Access Compliance Report

Public Rights-of-Way

Intersection ID: 48245	Main Street: LANIER_ISLANDS_CR	Cross Street: LAKE_ERIE_LN	Location: NE
ADA ID: 69CA2B8BDFCA	Ramp Type: PerpDiag	Initial Pass/Fail: Fail	Overall Compliance: No
		Severity Score: 12.5

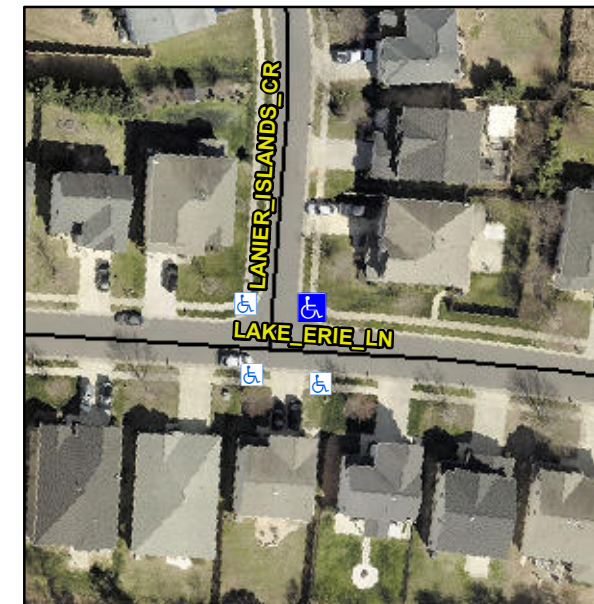
Not Found, R304.5.3

Compliance	Description	Data	Compliance	Description	Data
N/A	Ramp Length (in)	48.0	Yes	Ramp Slope (%)	5.6
Yes	Ramp Width (in)	48.0	No	Ramp XSlope (%)	6.7
N/A	Flare Type LT	N/A	N/A	Flare Type RT	N/A
N/A	Flare Slope LT (%)	N/A	N/A	Flare Slope RT (%)	N/A
N/A	Flare Traversable LT?	N/A	N/A	Flare Traversable RT?	N/A
N/A	Landing Length (in)	N/A	N/A	DWS Provided?	N/A
N/A	Landing Width (in)	N/A	N/A	DWS Contrast?	N/A
N/A	Landing Slope (%)	N/A	N/A	DWS Length (in)	N/A
N/A	Landing X Slope (%)	N/A	N/A	DWS Full Width?	N/A
N/A	Landing Curb? (Y/N)	N/A	N/A	DWS Offset (in)	N/A
N/A	Shared Landing?	N/A			
N/A	Gutter Ponding?	N/A	N/A	Gutter Slope (%)	N/A
N/A	Gutter Lip Ht (in)	N/A	N/A	Gutter X Slope (%)	N/A
N/A	Painted X Walk1?	No	N/A	Painted X Walk2?	No
	X Walk 1 Direction	To NW		X Walk 2 Direction	To SW
N/A	X Walk 1 Width (in)	N/A	N/A	X Walk 2 Width (in)	N/A
	X Walk 1 Slope (%)	1.3		X Walk 2 Slope (%)	4.2
	X Walk 1 X Slope (%)	4.7		X Walk 2 X Slope (%)	2.5

Remove & Replace Curb Ramp With Two New Directional Ramps or Equivalent.
